FIFTH FLOOR PLAN PROPOSED

EIGHTEEN SUNSET
1759 PURDY AVE
MIAMI BEACH, FLORIDA
07/16/18

ROOF DECK PLAN PROPOSED

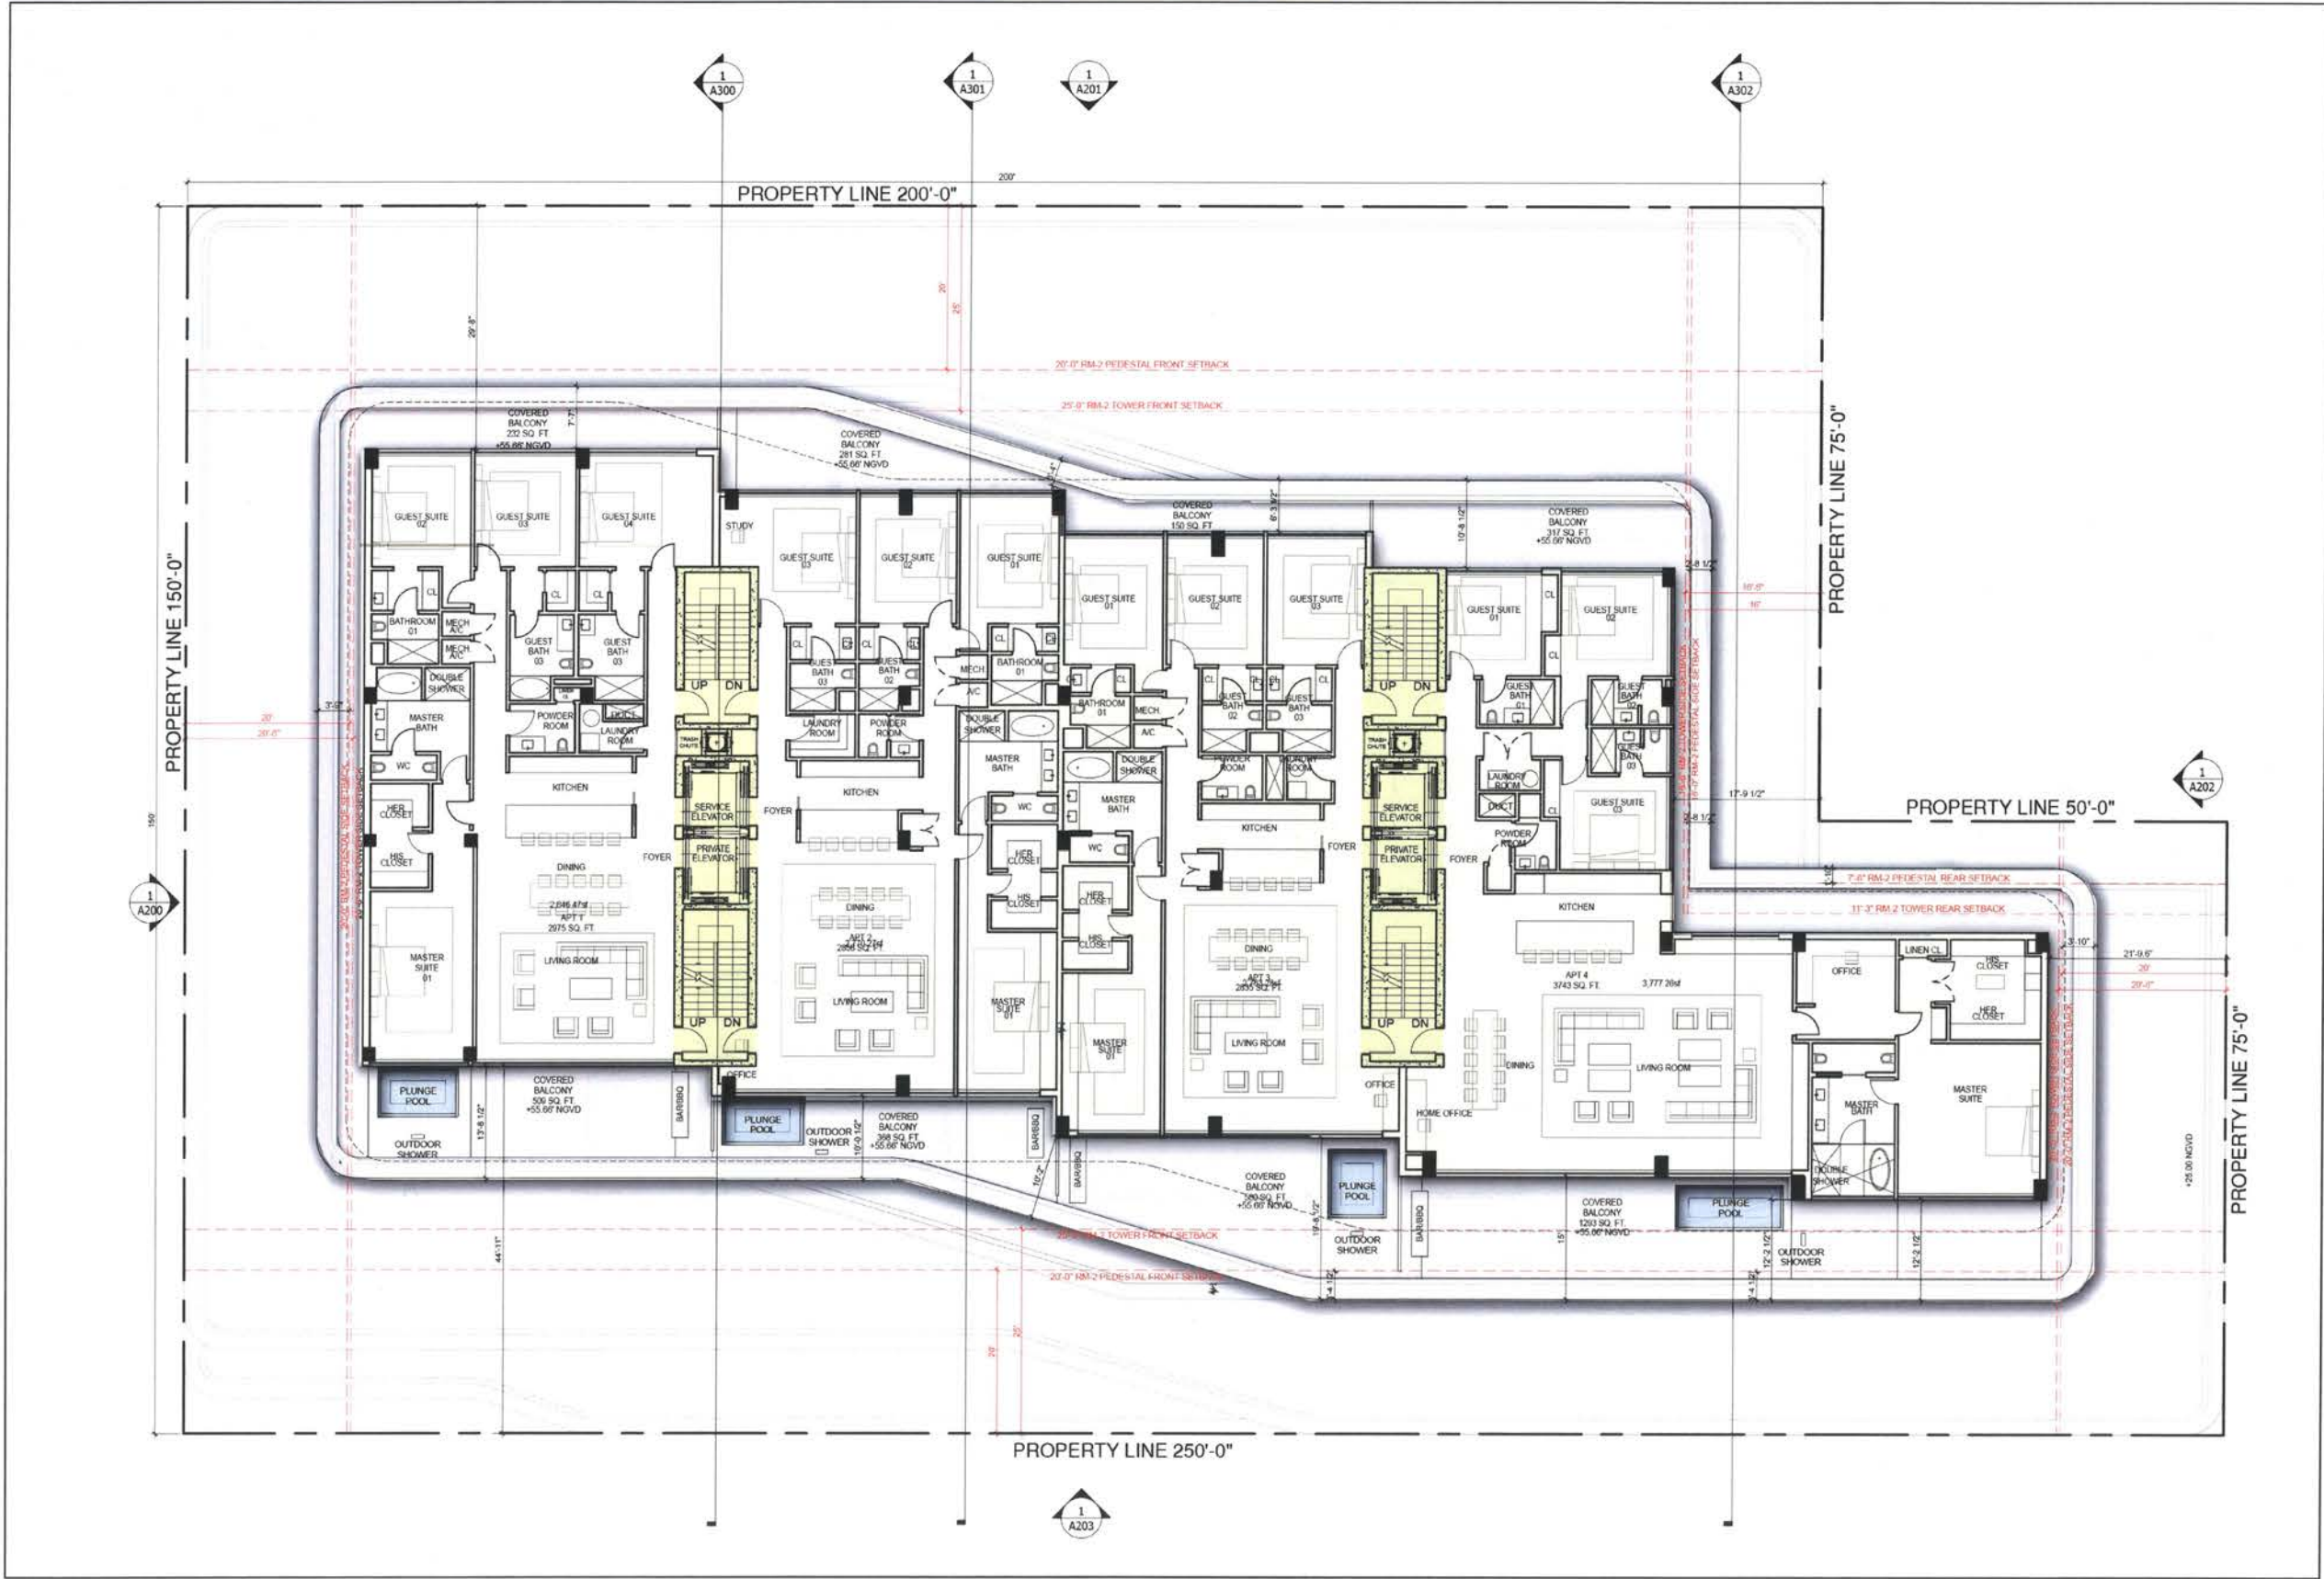
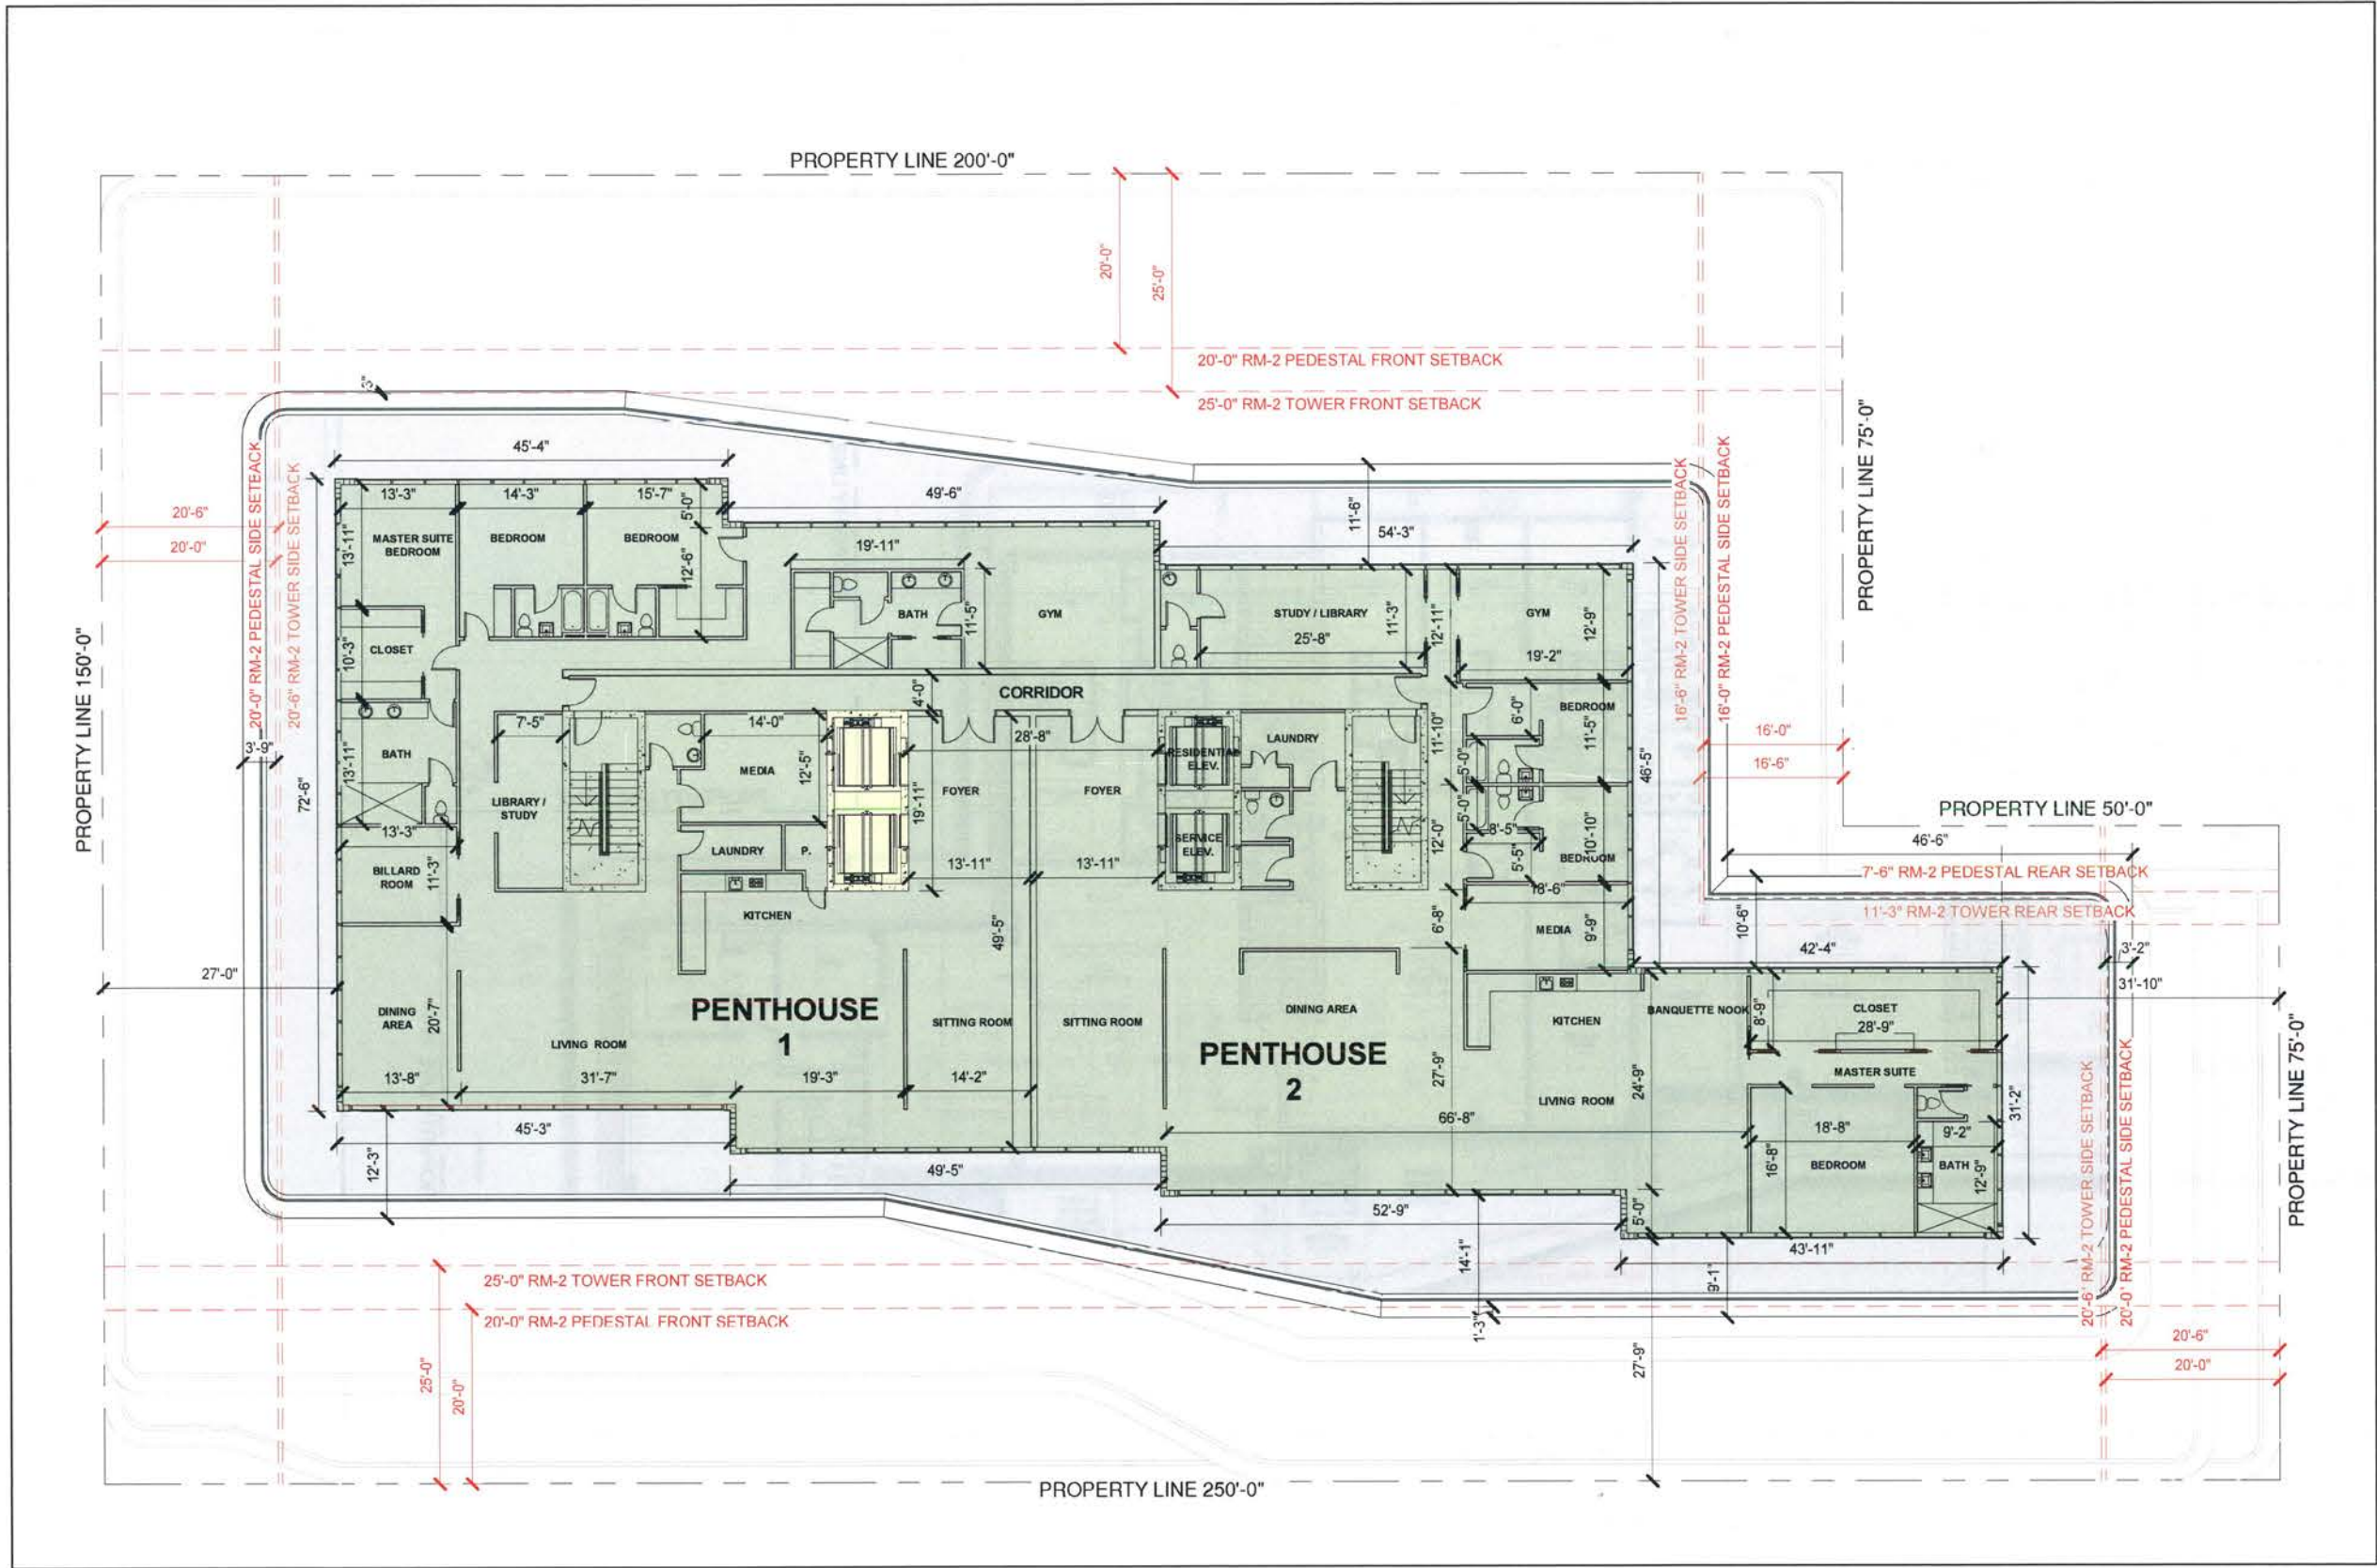
Area	FAR sq.ft	NON FAR sq.ft
Penthouse 1	5,388	
Penthouse 2	5,452	
Corridor	495	
N. Stair Core	197	
S. Stair Core	197	
N. Elevator Core	197	
S. Elevator Core	197	
Terrace		4,747
Total Floor FAR	12,123	
Total Floor Non FAR		4,747
Total Floor R-2 (25%)	11,926

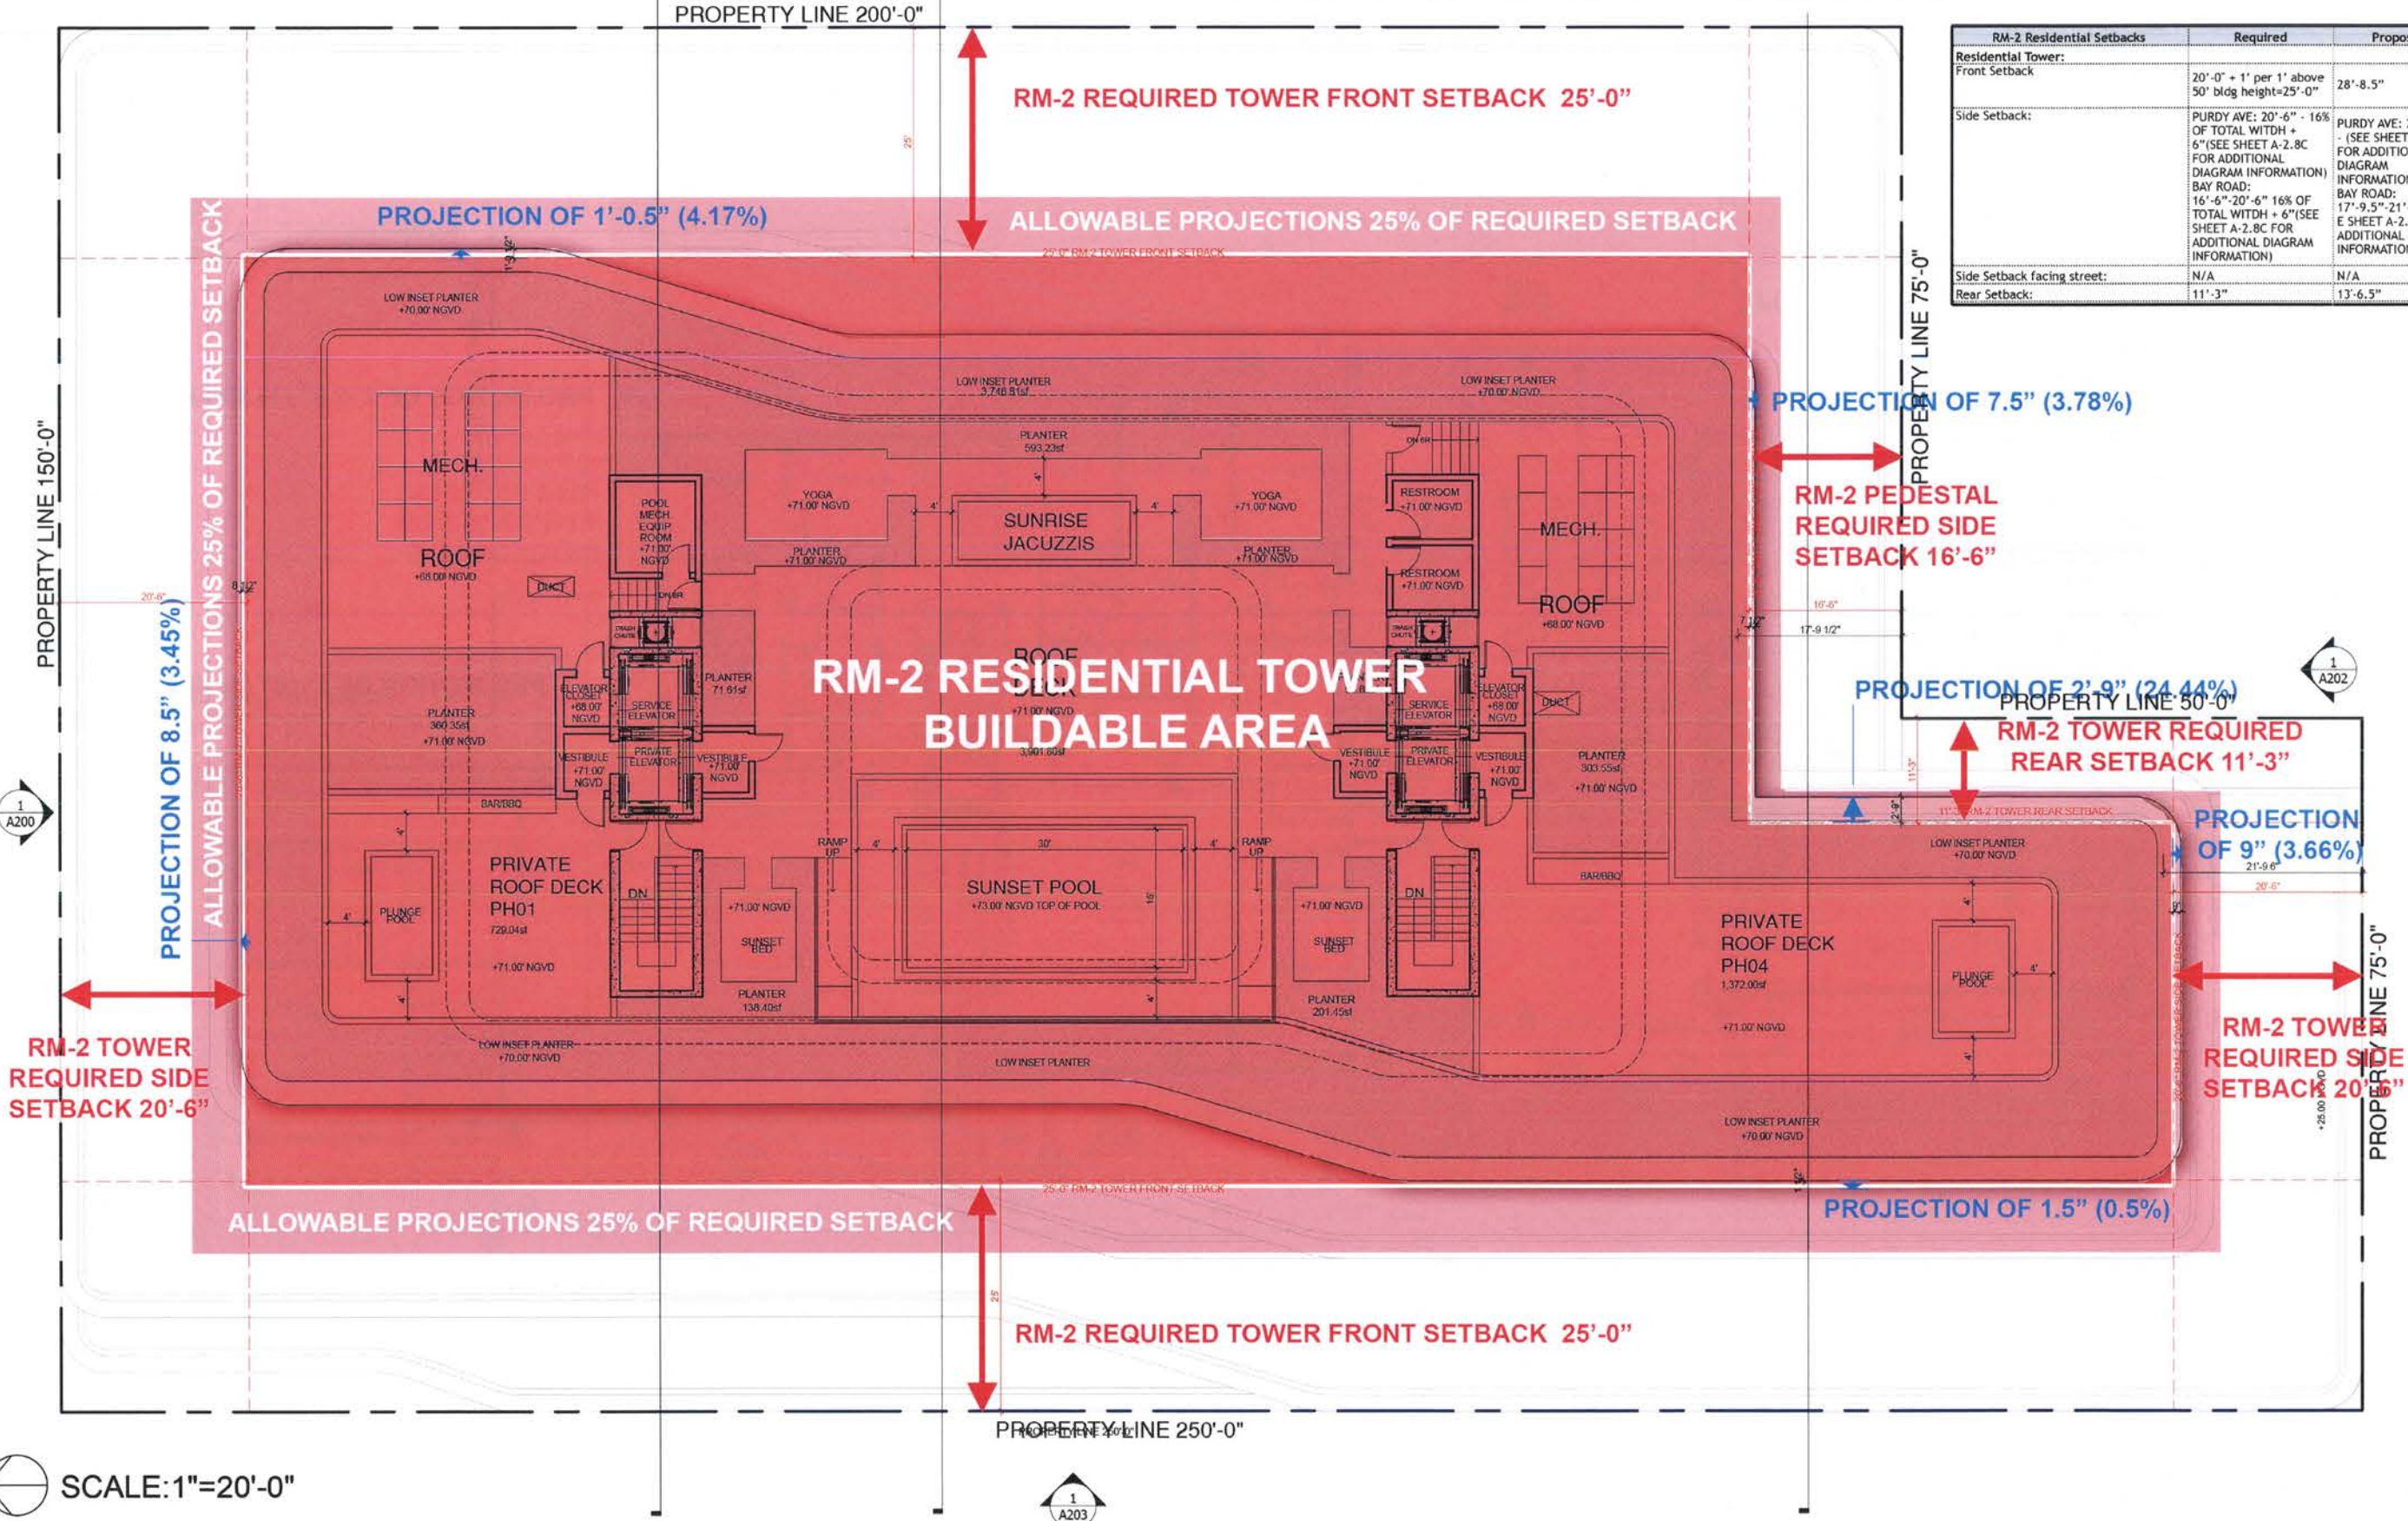
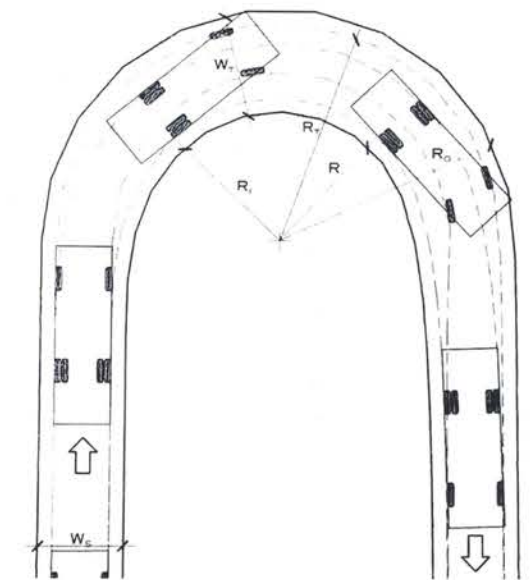
SEE TRAFFIC STUDY FOR MINOR CHANGES IN TRASH LOADING OPERATIONS.
